Thermo King - Bloomington

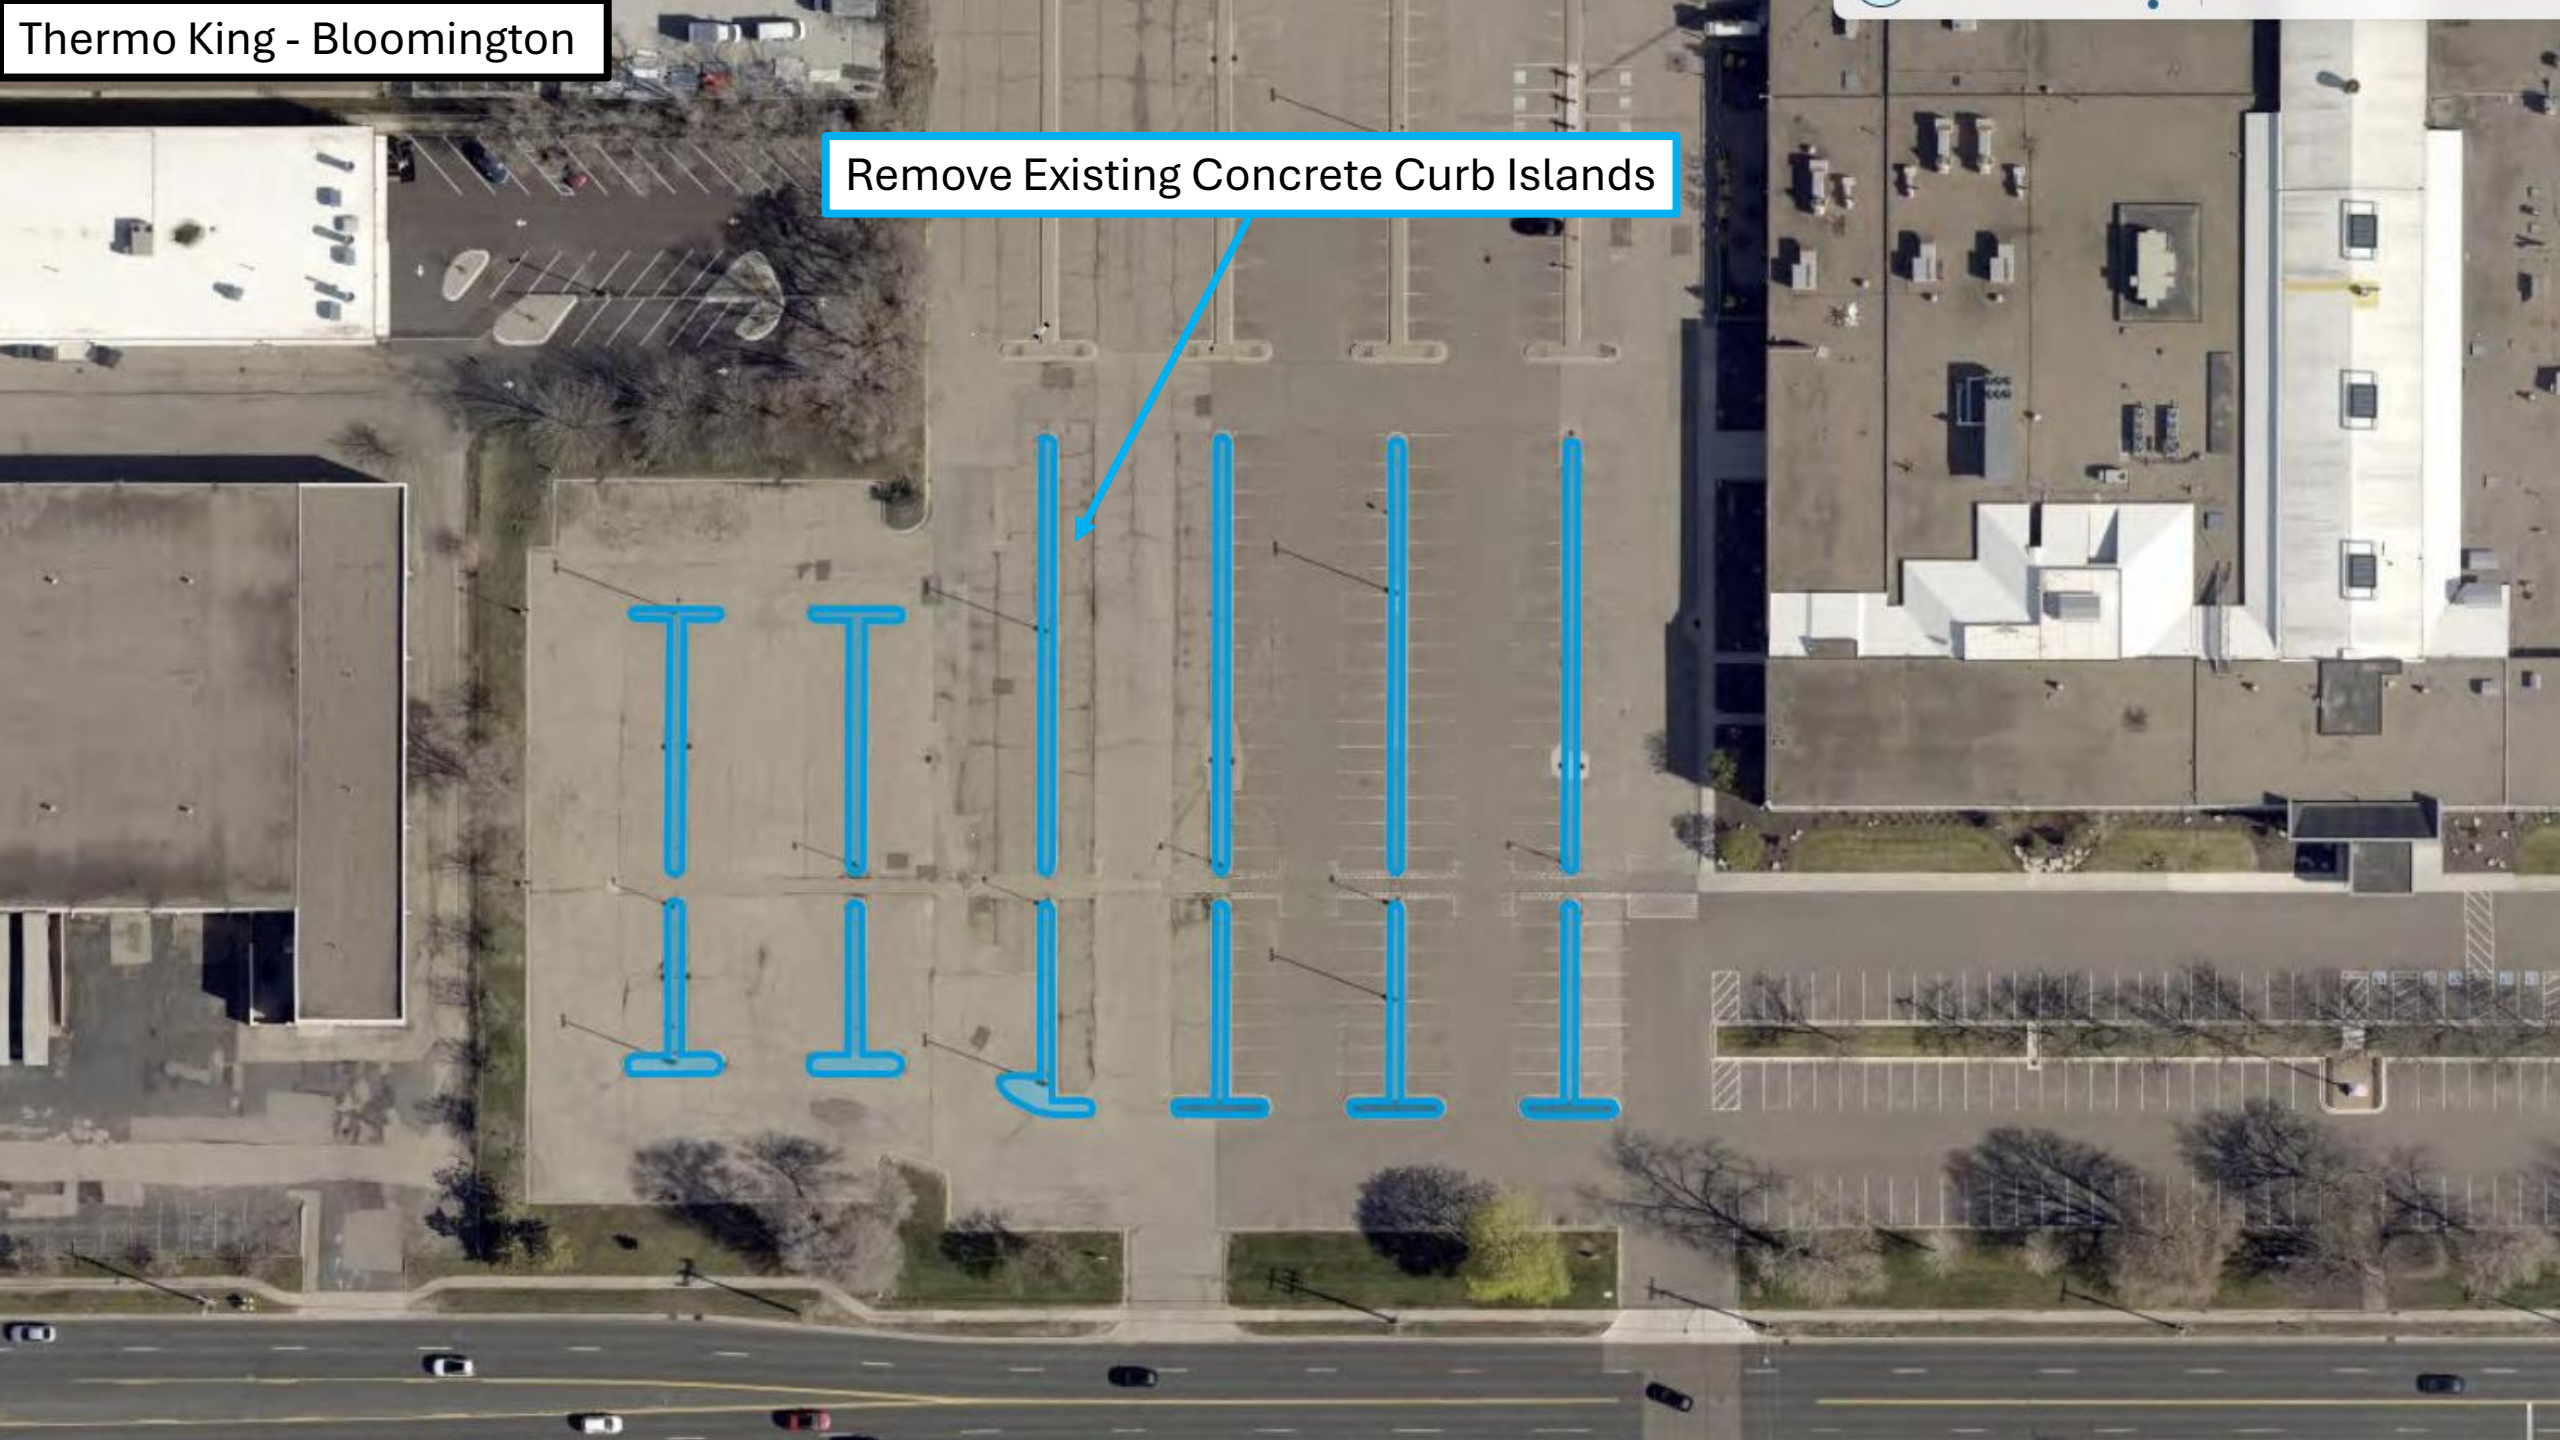
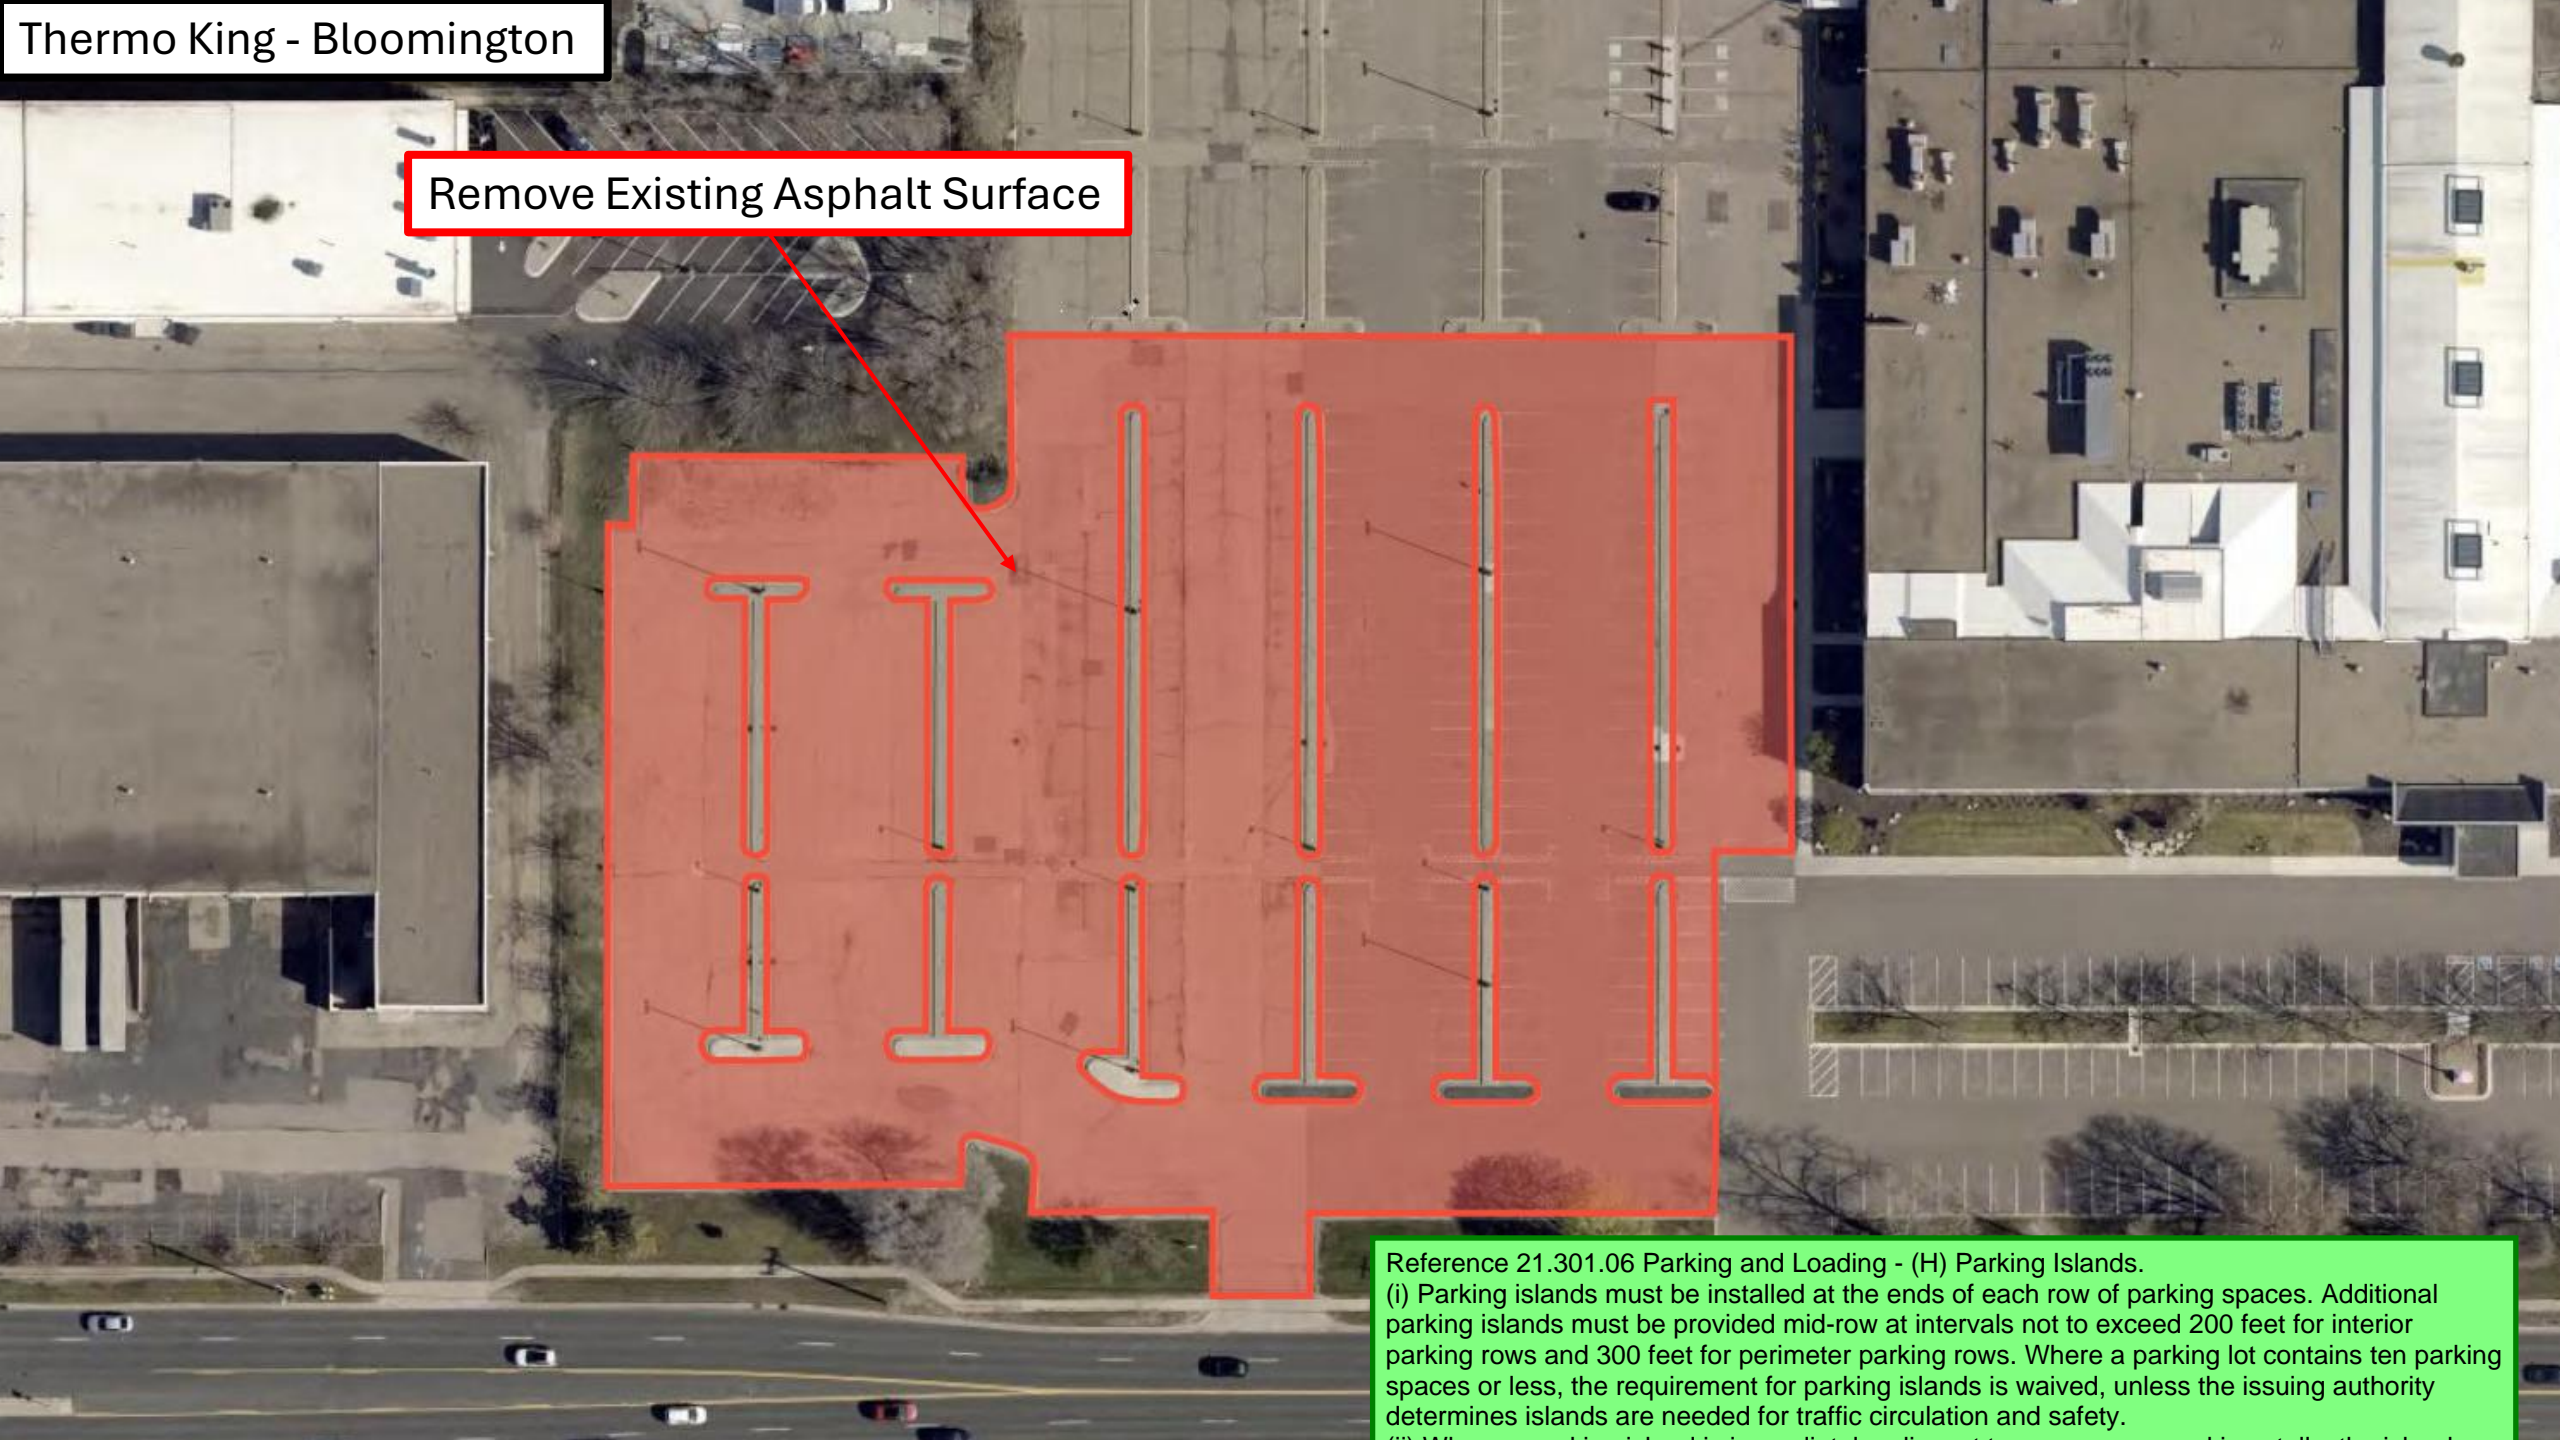
Reference 21.301.06 Parking and Loading - (H) Parking Islands.
(i) Parking islands must be installed at the ends of each row of parking spaces. Additional parking islands must be provided mid-row at intervals not to exceed 200 feet for interior parking rows and 300 feet for perimeter parking rows. Where a parking lot contains ten parking spaces or less, the requirement for parking islands is waived, unless the issuing authority determines islands are needed for traffic circulation and safety.

Must meet 2020 MN State Building Code

Must meet 2020 MN Accessibility Code.

A Parking Lot permit shall be required for any re-striping.

Provide required accessible stalls per 2020 MN State Accessibility code.

Maintain emergency vehicle access and circulation throughout the property.

Maintain access to all hydrants.

This is a separate platted lot. If chance of selling, make sure new curb meets setback from lot line.

Landscape plan is needed; reference 21.301.15 Landscaping and Screening.

Parking code analysis is needed. The analysis will determine how many parking spaces is required per uses: sq. ft of 1. Manufacturing. 2. Warehouse/distribution. 3. Office. 4. Total supply of parking on site.

Provide grading and restoration plans in future submittals.

Show existing and proposed storm sewer.

Use City Standard detail for Non-Residential Driveway approach if driveway is impacted
